**Notice of a Meeting**  
**Dalworthington Gardens Planning and Zoning Commission**

3. Discussion and possible recommendation on an application for a preliminary plat submitted by Aldriedge Building Corp for Lot 19, Block A, 1.001 acres of land located in The Joseph Pierce Survey, Abstract No. 1253 an addition to the City of Dalworthington Gardens, Tarrant County, Texas, and locally known as 3815 Kelly Perkins Road.

- i. Conduct a public hearing
  - ii. Discussion and action
4. Discussion and possible recommendation on an application for a final plat submitted by Aldriedge Building Corp for Lot 19, Block A, 1.001 acres of land located in The Joseph Pierce Survey, Abstract No. 1253 an addition to the City of Dalworthington Gardens, Tarrant County, Texas, and locally known as 3815 Kelly Perkins Road.

Engineer Review #1 with comments

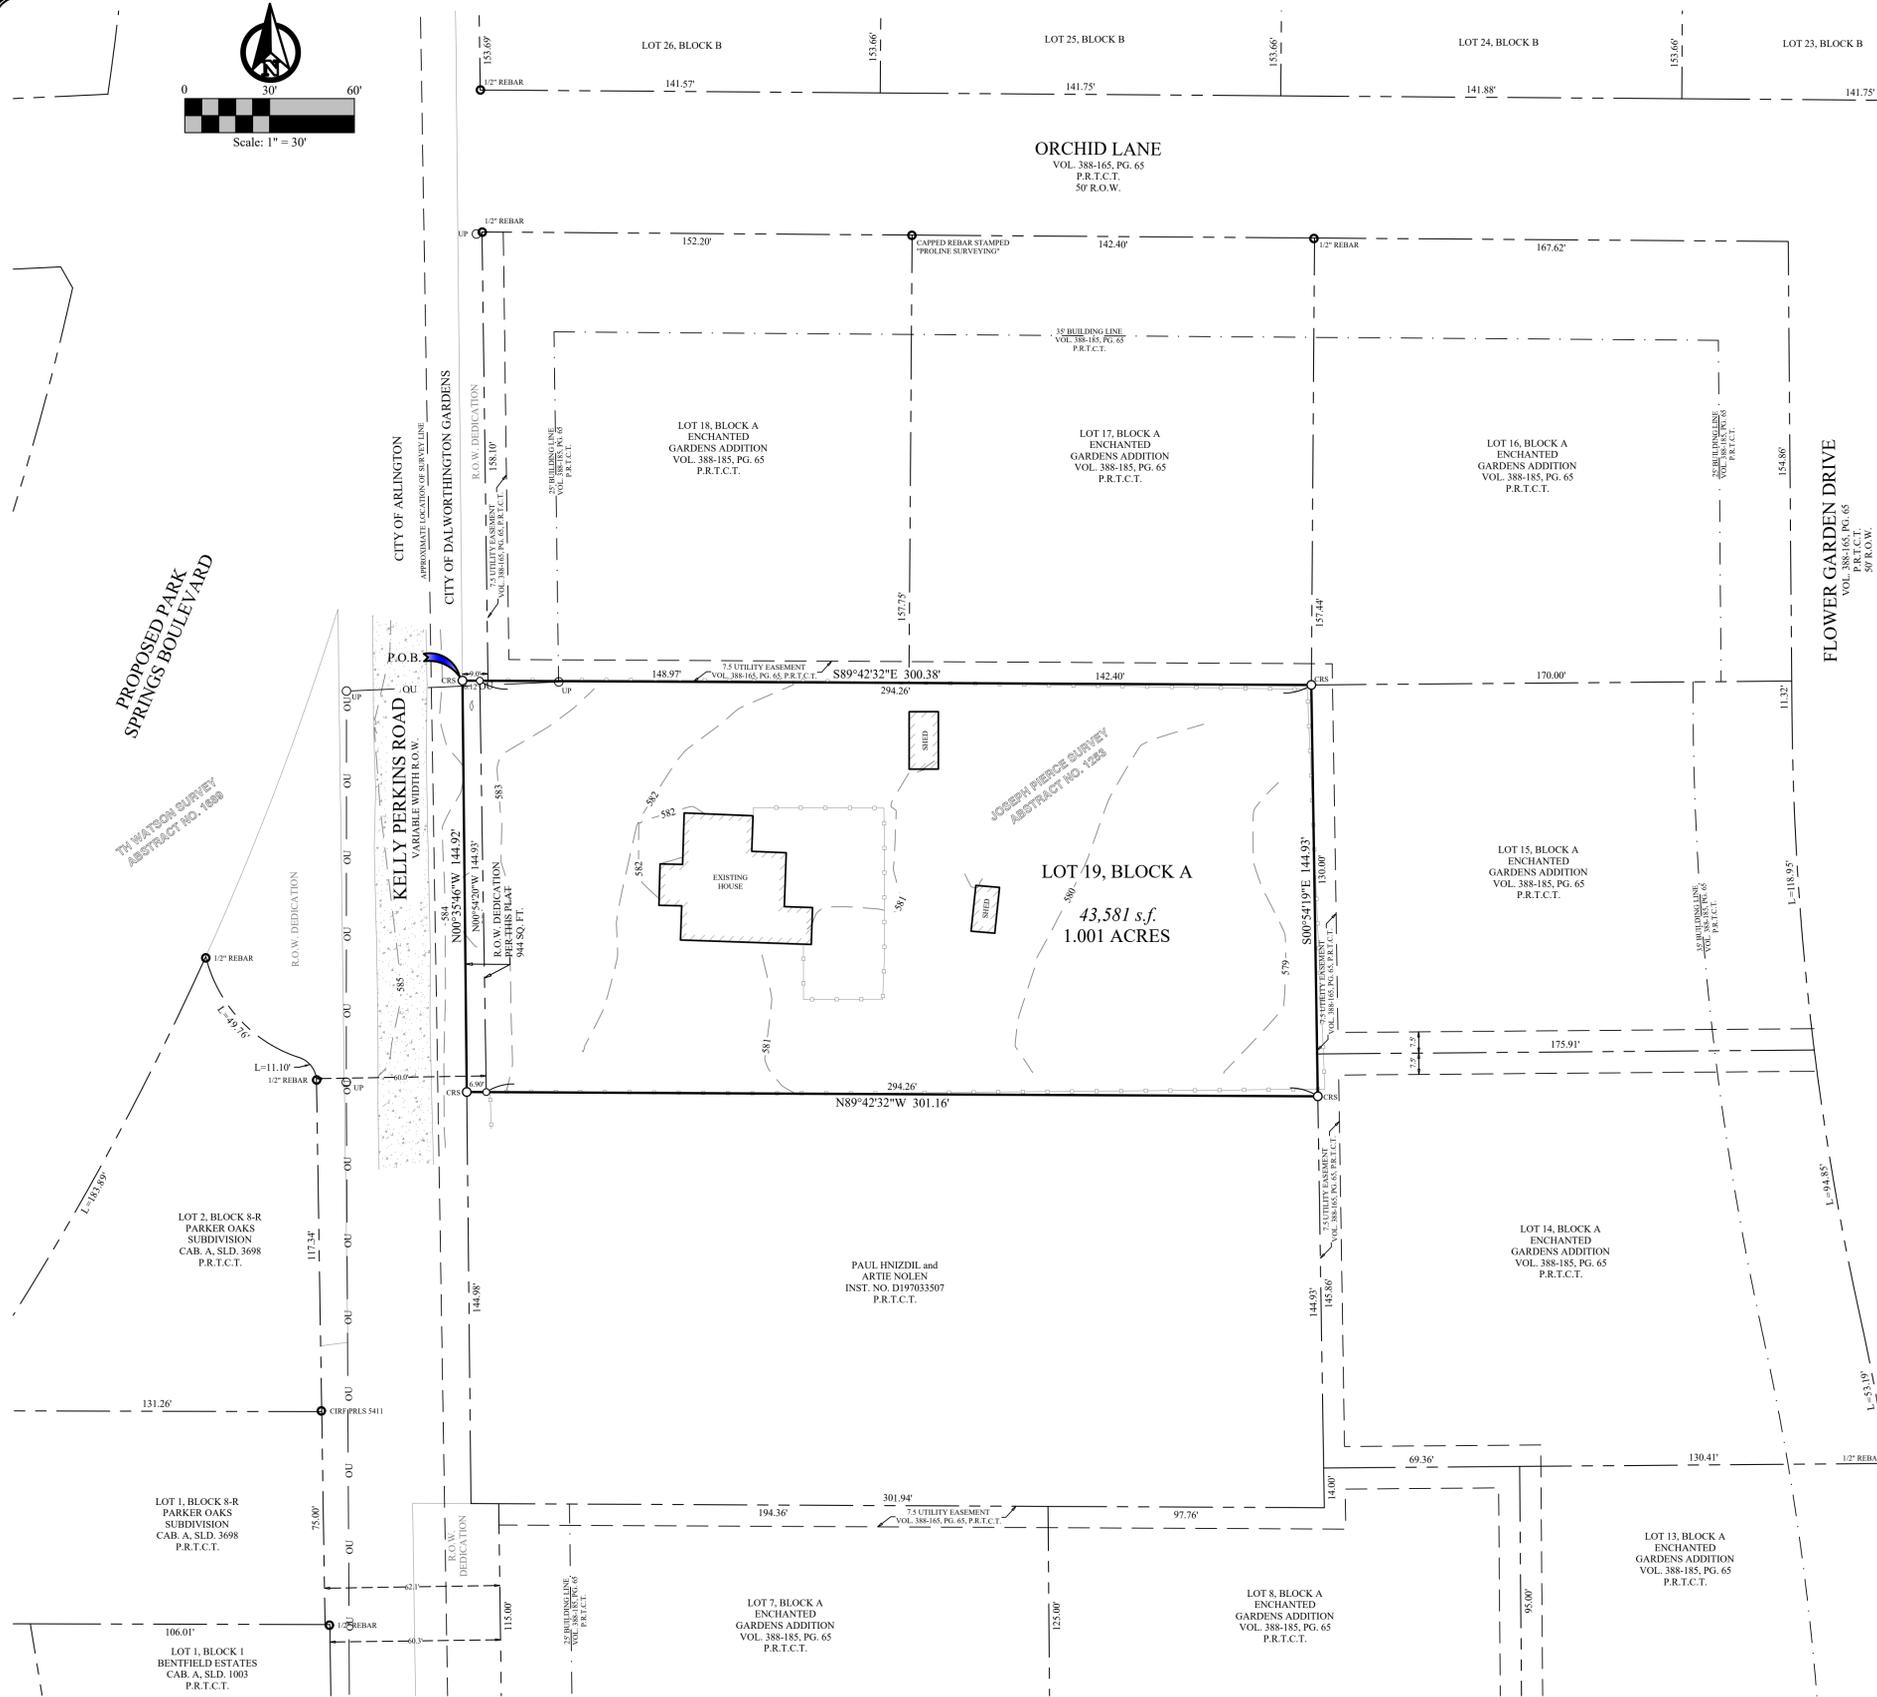
- 1) Provide the names of all adjacent property owners and match descriptions with the Appraisal District records.
- 2) Show and label all building setbacks per section 14.02.171 or the Code of Ordinances.

- 3) Show and label all existing utilities on and adjacent to the property and label the line sizes.
- 4) Note benchmarks used.
- 5) Any major proposed changes in topography shall be shown by labeled contour lines.

- 6) Provide a preliminary water and sewer exhibit that shows how water and sewer service will be provided to the lot.
- 7) Label the lot acreage minus the ROW dedication.

- 8) Provide a preliminary drainage plan to show how the property will drain.
- 9) Label the right of way width for all roadways.
- 10) Include the certifications and statements listed in section 10.02.123/2 and verify that they match the ordinance exactly. These certifications and statements can be found as attachments to Chapter 10 of the online Code of Ordinances.

- 1) Revise the name of the plat to be only “Preliminary Plat”.
- 2) Add a note stating that the maximum building coverage of the lot shall be 25%.
- 3) Add a note stating that the maximum impervious coverage of the lot shall be 40%.

- 4) Accessory buildings such as shed cannot be within the building setbacks. Label all existing structures as either to remain or to be removed.
- 5) Show and label all existing utilities on and adjacent to the property and label the line sizes.

- 6) Provide a preliminary water and sewer exhibit that shows how water and sewer service will be provided to the lot.
- 8) Any major proposed changes in topography shall be shown by labeled contour lines.

- 9) Provide a preliminary drainage plan to show how the property will drain.
- 10) Renumber notes so that number 4 is not skipped.
- 11) Revise the “Owner’s Certificate” so that it matches the template provided as an attachment to Chapter 10 of the online Code of Ordinances.

- 12) Revise the “Surveyor’s Certificate” so that it matches the template provided as an attachment to Chapter 10 of the online Code of Ordinances.
- 13) Revise the “City Approval Statement” so that it matches the template provided as an attachment to Chapter 10 of the online Code of Ordinances. The preliminary plat shall use “City Secretary”

- 14) In note 7, add a reference to section 10.02.227 of the subdivision ordinance.
- 15) Remove note 3 and add the deed restriction certification statement provided as an attachment to Chapter 10 of the online Code of Ordinances.

**FINAL PLAT**  
**BLISS ADDITION**  
**LOT 19, BLOCK A**  
 BEING 1.001 ACRES OF LAND LOCATED IN  
 THE JOSEPH PIERCE SURVEY, ABSTRACT NO. 1253  
 AN ADDITION TO THE CITY OF DALWORTHINGTON GARDENS,  
 TARRANT COUNTY, TEXAS

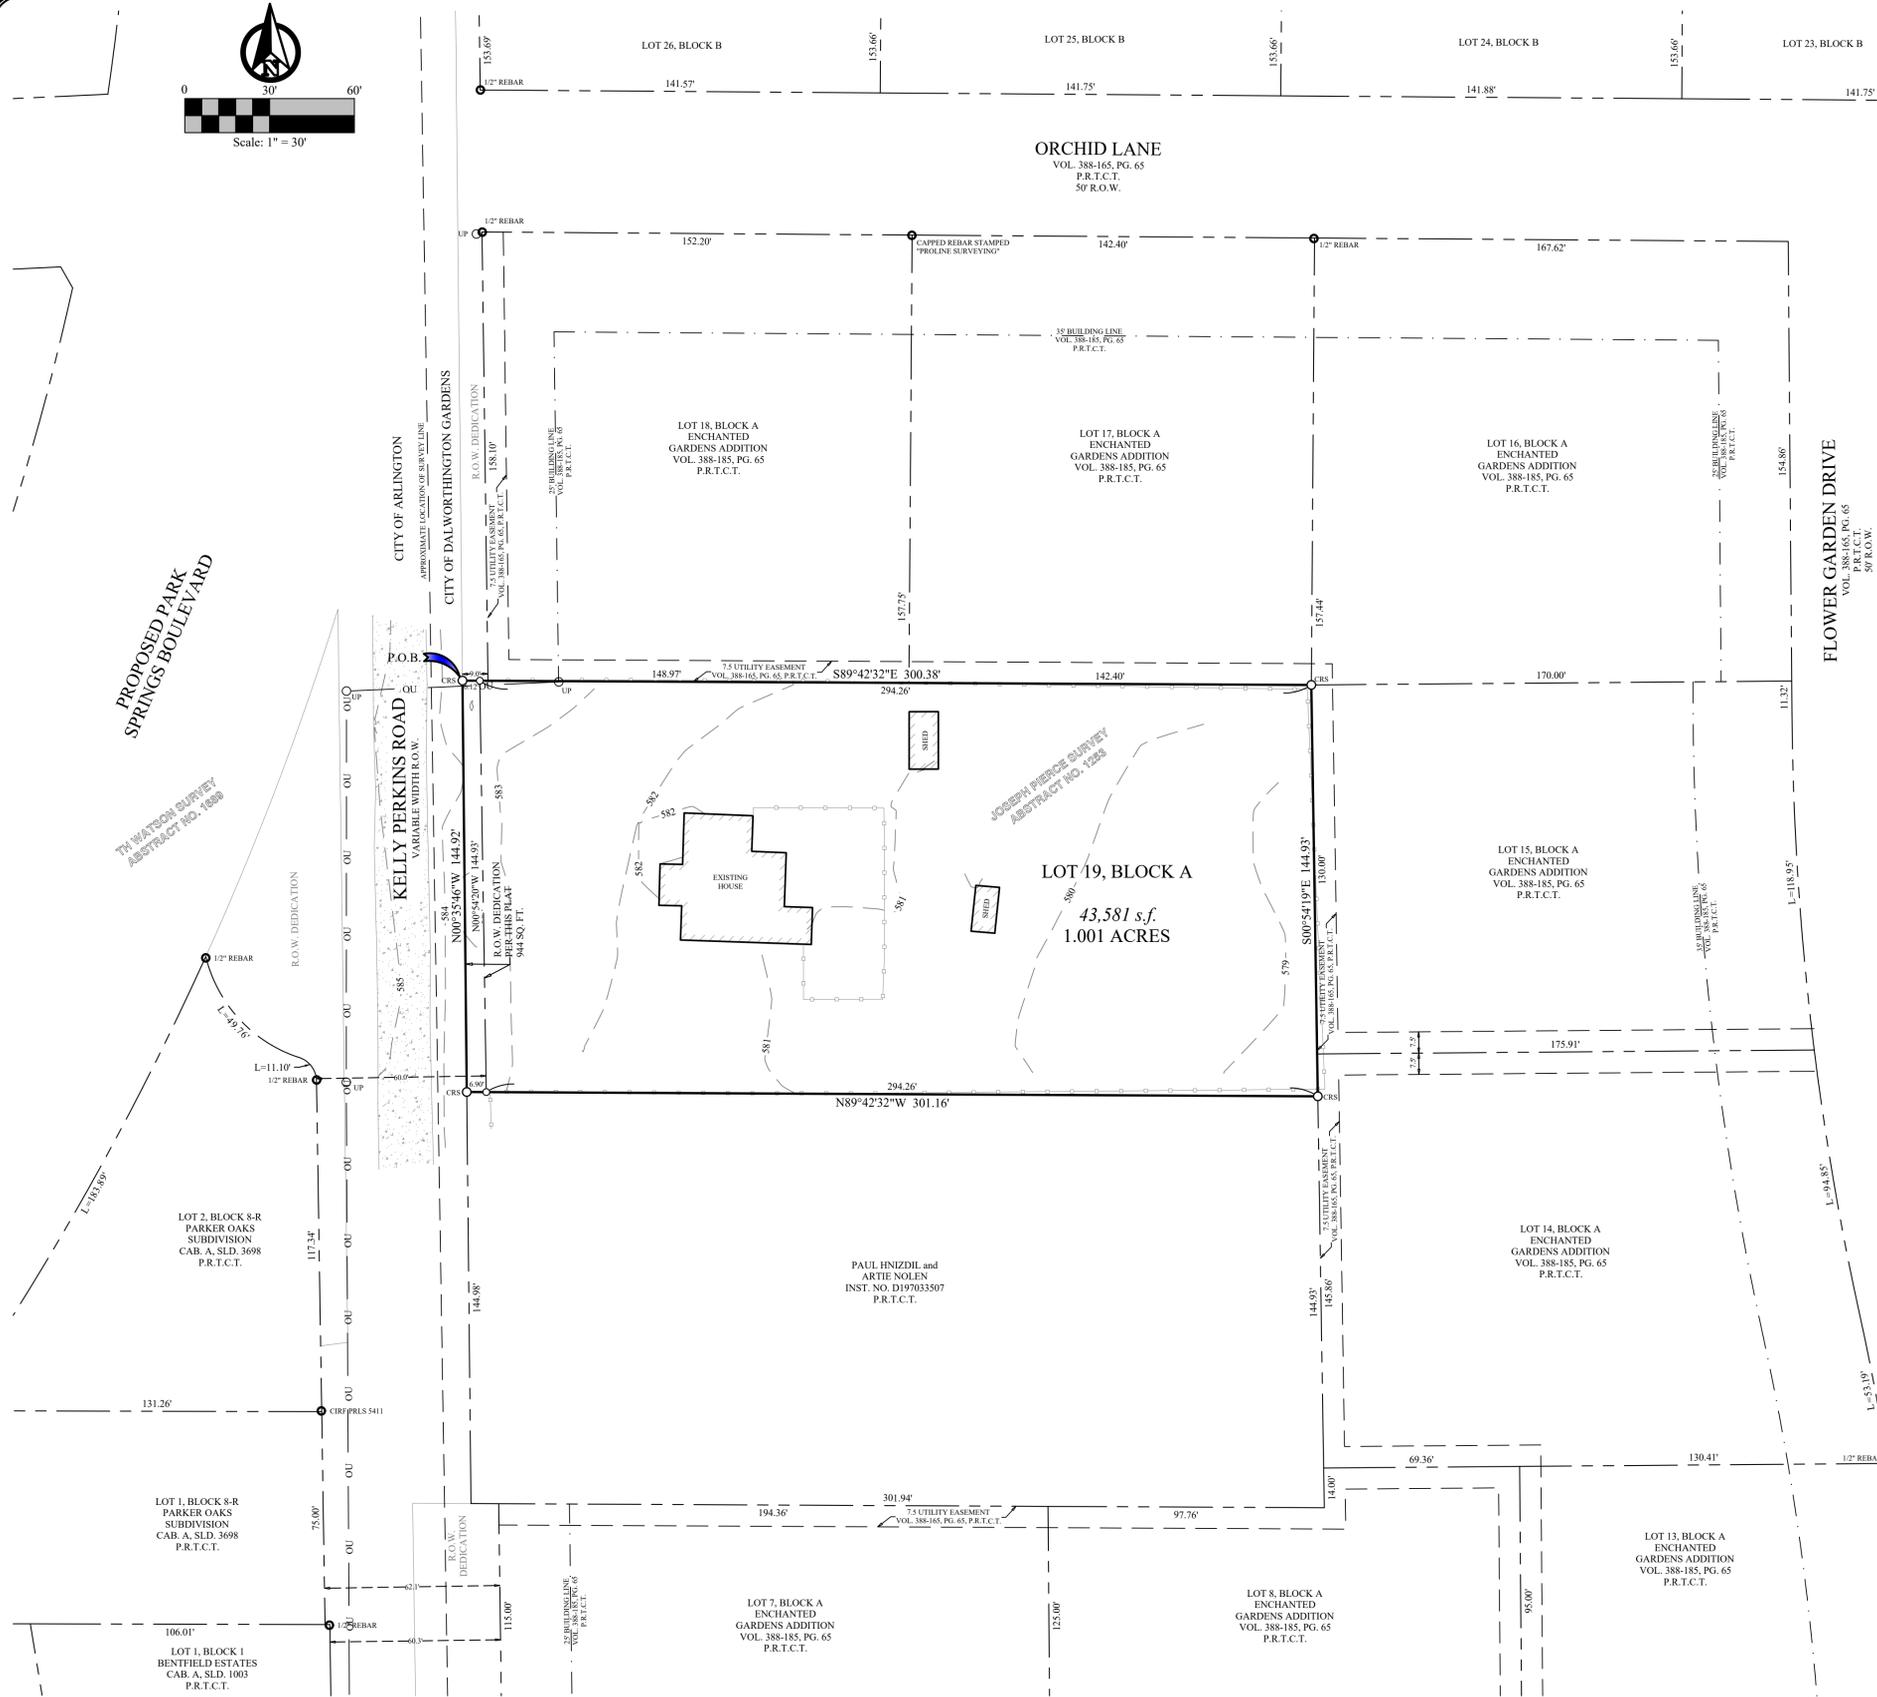
- 1) Revise the name of the plat to be only “Final Plat”.
- 2) Remove the preliminary statement above the title block.
- 3) Add a note stating that the maximum building coverage of the lot shall be 25%.

- 4) Add a note stating that the maximum impervious coverage of the lot shall be 40%.
- 5) Remove topography and all existing fences, pavement linework, structures, utilities, etc.

- 8) Renumber notes so that number 4 is not skipped.
- 9) Revise the “Owner’s Certificate” so that it matches the template provided as an attachment to Chapter 10 of the online Code of Ordinances.

- 10) Revise the “Surveyor’s Certificate” so that it matches the template provided as an attachment to Chapter 10 of the online Code of Ordinances.
- 11) Revise the “City Approval Statement” so that it matches the template provided as an attachment to Chapter 10 of the online Code of Ordinances. The final plat shall use “Council” and “Mayor” instead of “City Secretary”.

- 12) In note 7, add a reference to section 10.02.227 of the subdivision ordinance.
- 13) Remove note 3 and add the deed restriction certification statement provided as an attachment to Chapter 10 of the online Code of Ordinances.
